## Product Change Notification / SYST-31TCNJ739

ERRATA - PIC18F27/47K40 Family Silicon Errata and Data Sheet Clarification

## PIC18(L)F27/47K40 Family Silicon Errata and Data Sheet Clarifications

The PIC18(L)F27/47K40 devices that you have received conform functionally to the current device data sheet (DS40001844E), except for the anomalies described in this document.

Figure 1. 28-pin SPDIP, SSOP, SOIC

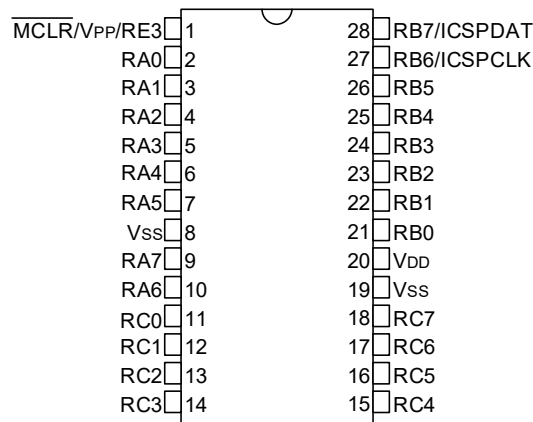
The correct marking for pin 26 on the 28-pin SPDIP/SSOP/SOIC package is **RB5**.

Figure 38-10: ADC Conversion Timing (ADC Clock  $F_{OSC}$ -Based)

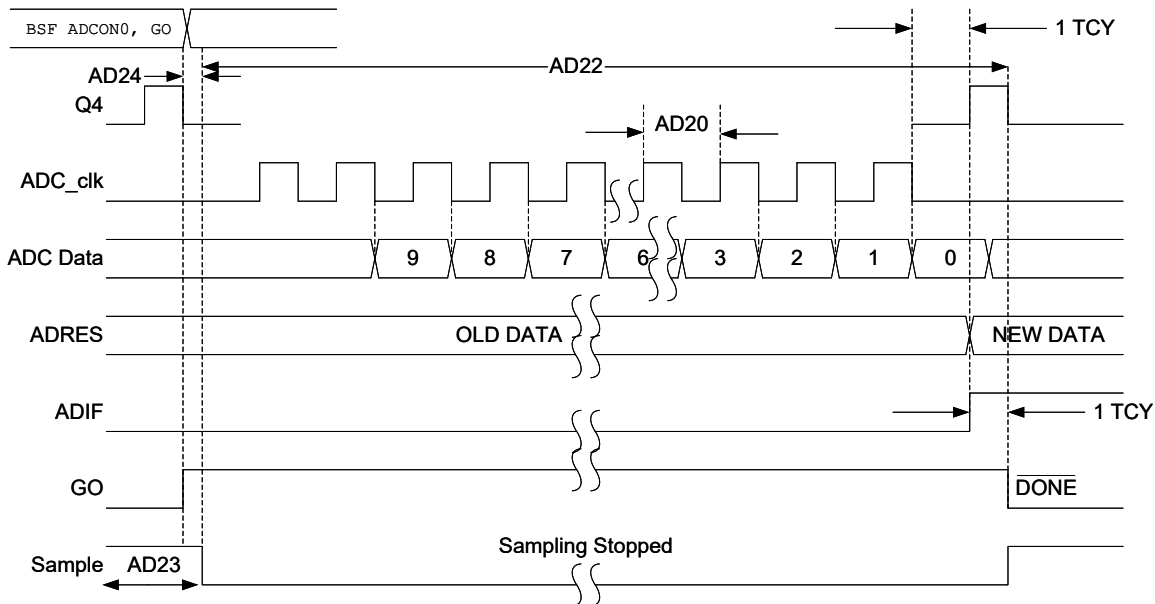
Refer to the images below for corrections of Figure 38-10 and Figure 38-11. Previously, the parameter numbers were incorrect.
